From: Kristen Kapelanski, AICP
 Date: 3/24/2021
 Re: **Barns Senior Living (City File #20-023)**
Site Plan - Planning Review #4

FILE NO: 20-023 REVIEW NO: 4

From: Jason Boughton, AC, Engineering Utilities Specialist
To: Kristen Kapelanski, AICP, Planning Manager
Date: March 22, 2021
Re: Barns Senior Living, City File #20-023, Section 20
Site Plan Review #4

CITY OF ROCHESTER HILLS
STANDARD DETAIL FOR:
Sight Distance Pathways

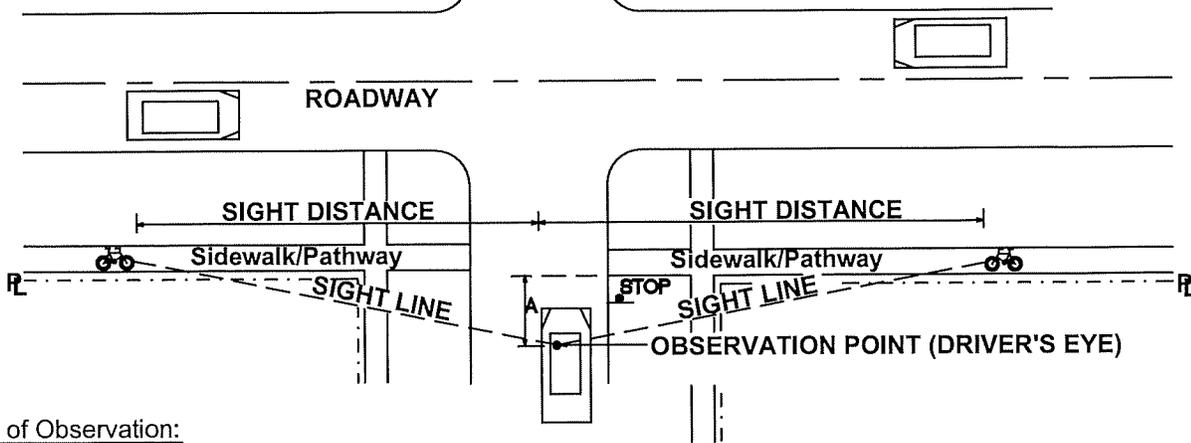
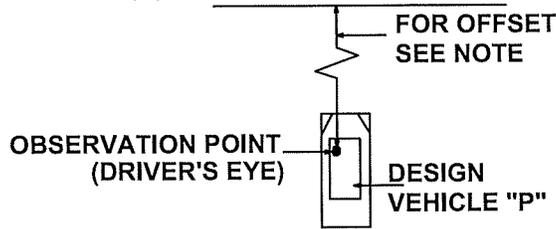
1. The road and pathway sight distance lines should be accurately depicted and transferred to the Landscape Plan. Currently the Site Plan shows a 145 foot sight line for both road and pathway. Whereas the pathway sight distance is accurate, the road sight distance is not (should be 500 feet). In addition, both sight lines are connected by a straight line in between the driveways when they should continue on an angle. (See attached details for reference.)
2. Provide "one way" signage location and detail on plan view and detail sheets.
3. Please correct misspelling of Rochester Hills under the "Prepared For" header.
4. Clarify if the reference to Powell Engineering on the Utility Plan is necessary.
